STATE OF OHIO
DEPARTMENT OF TRANSPORTATION

FRA-161-15.80
NOISE WALLS

STAGE 2 SUBMITTAL 01/22/24

MAINTENANCE OF TRAFFIC PLAN
81" BARRIER 3

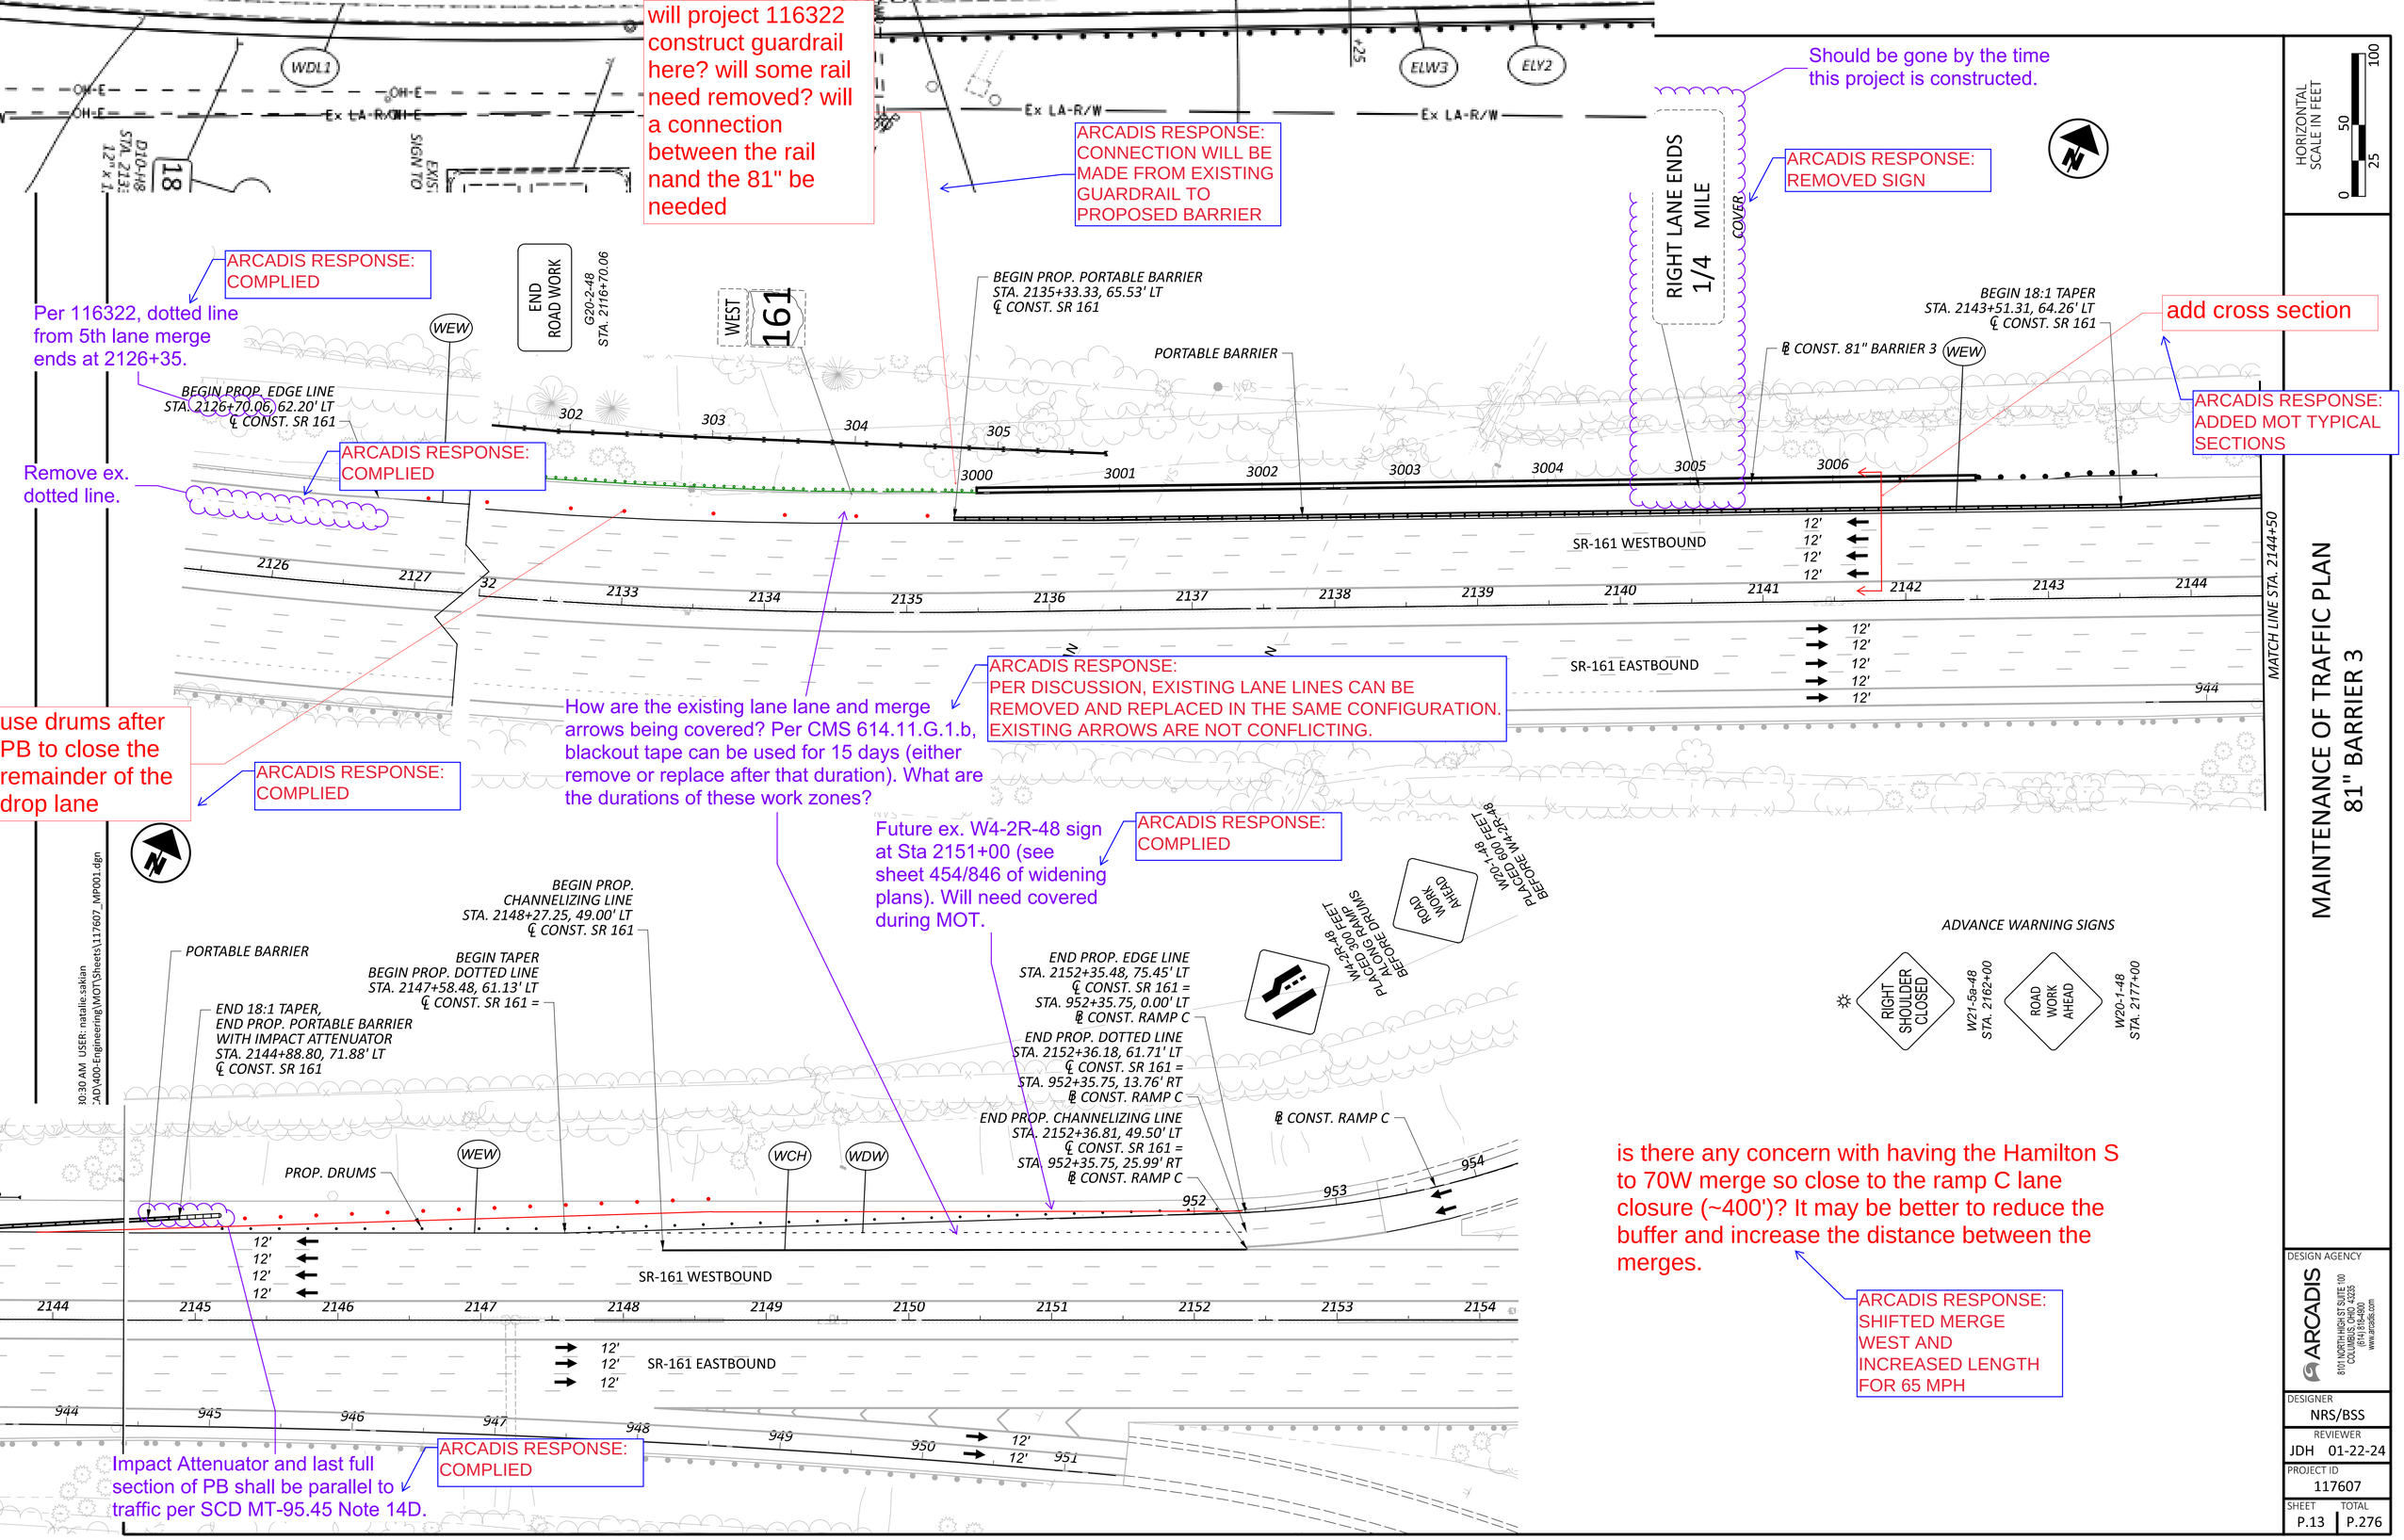
Future ex. W4-2R-48 sign at Sta 2151+00 (see sheet 454/846 of widening plans). Will need covered during MOT.

ARCADIS RESPONSE: COMPLIED

PLAN & PROFILE - WALL 11
STA. 2231+00.00 TO STA. 2236+00.00

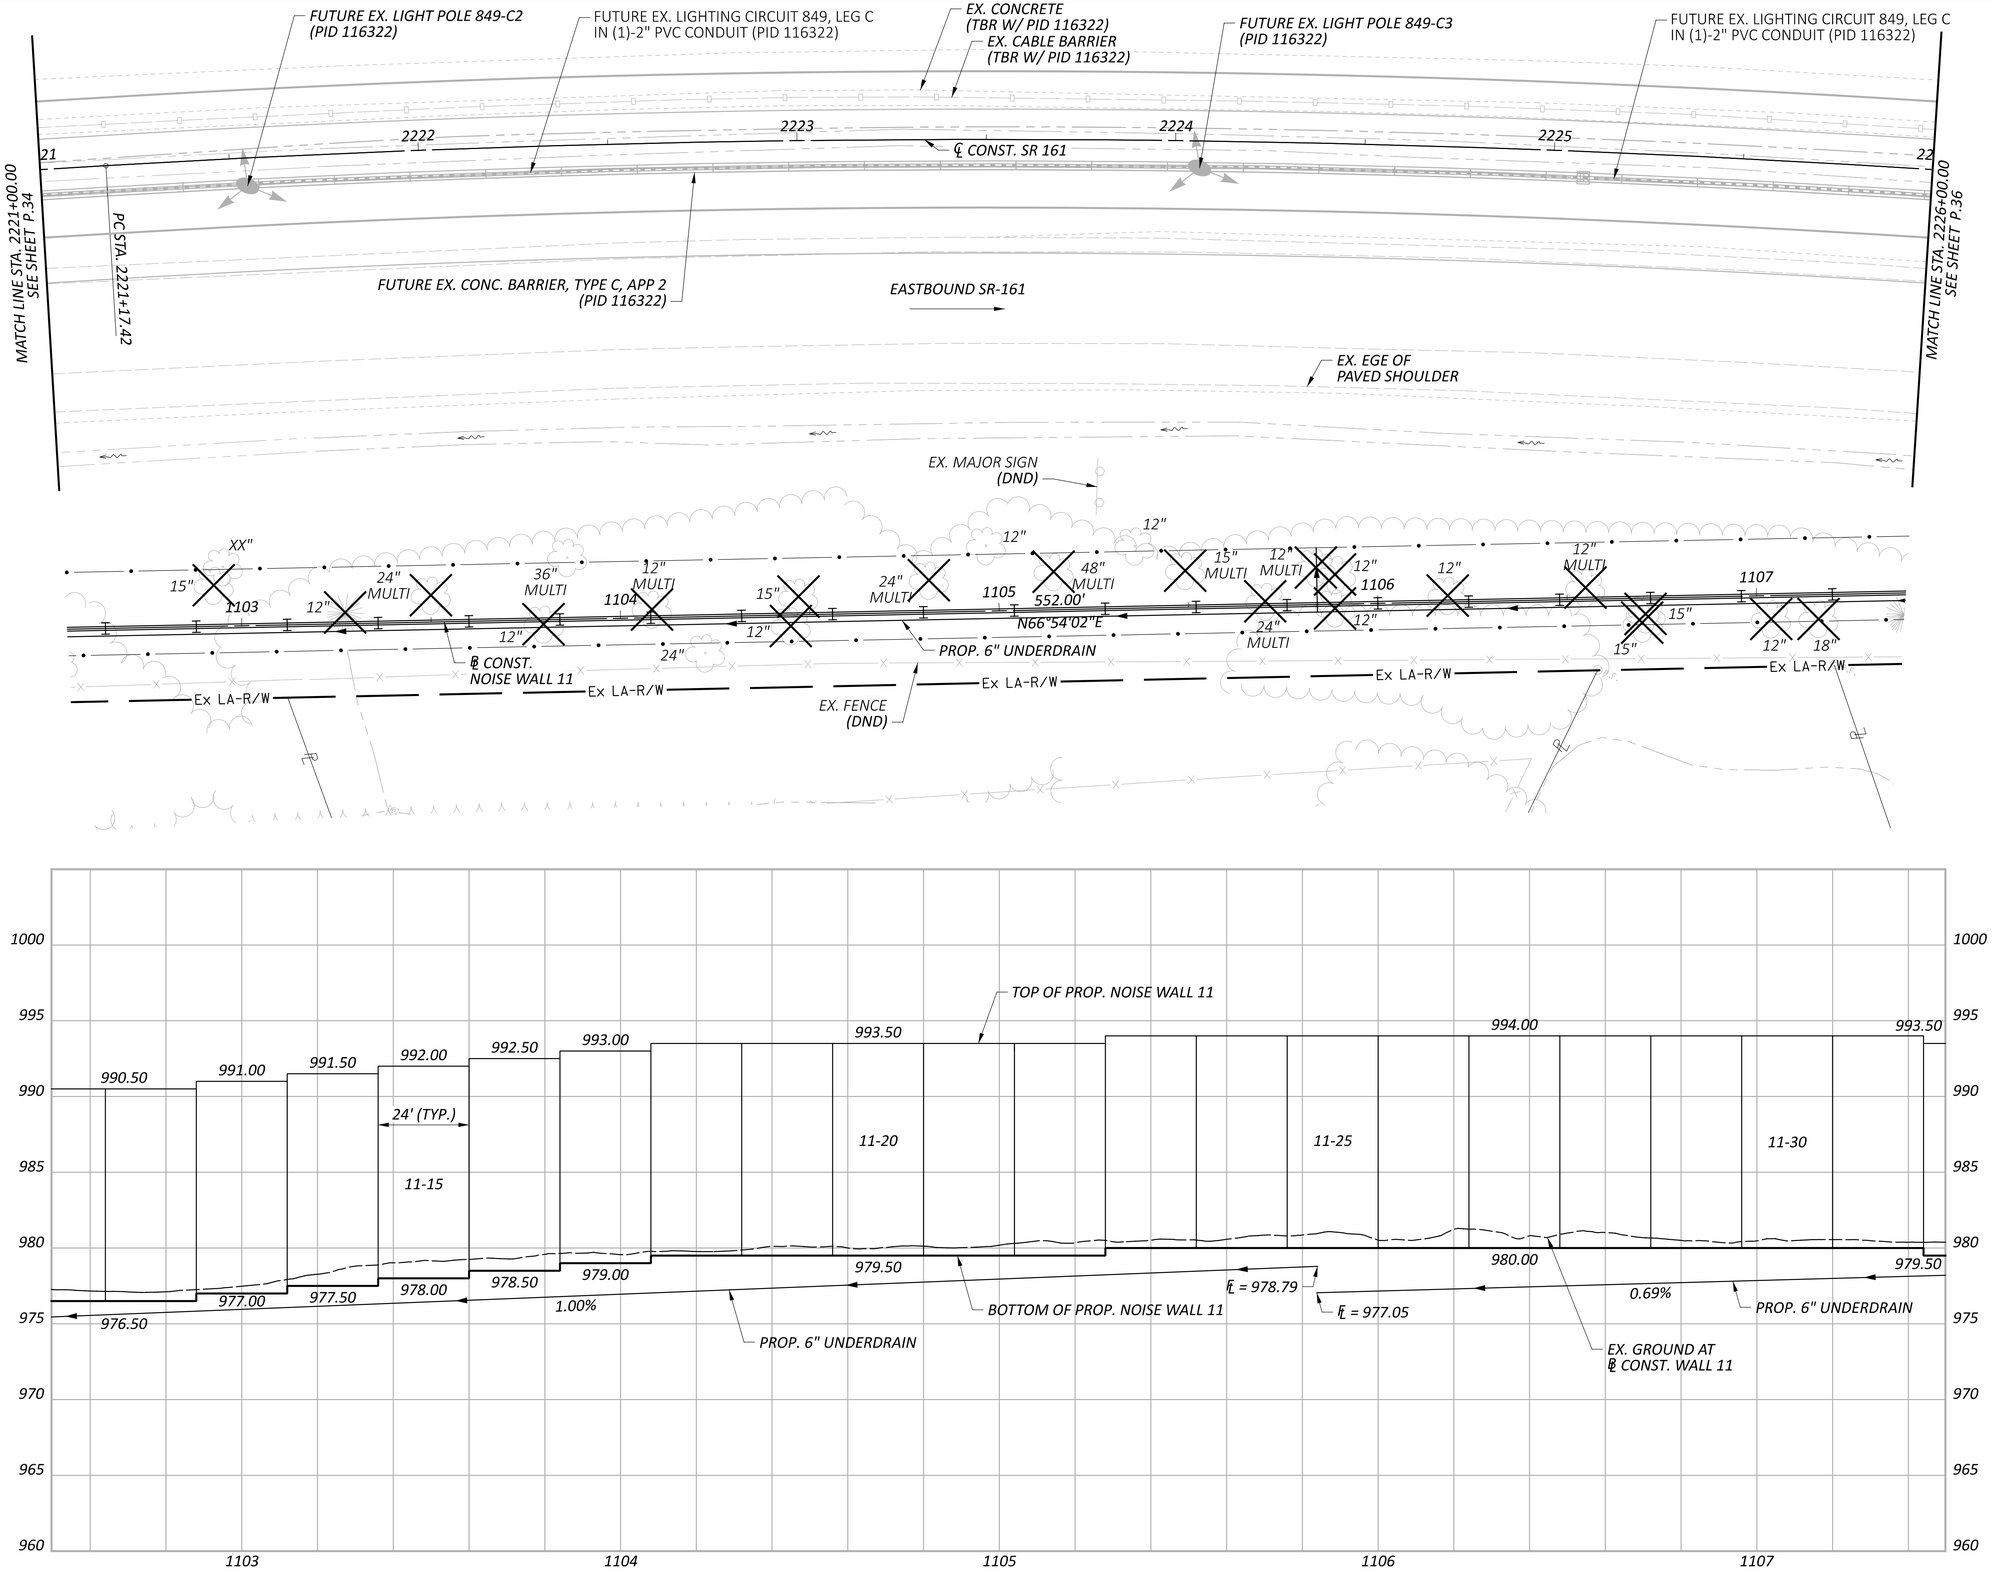
Typical section for paving and guardrail prior to Barrier 12? Maybe show on Wall 11's typical (~sta. 1114+15 to 1115+15). Paving width needs to be at least 4', from plan sheet P.37/P.276, it looks like it tapers to ~1'.

ARCADIS RESPONSE:
Complied (typical added)
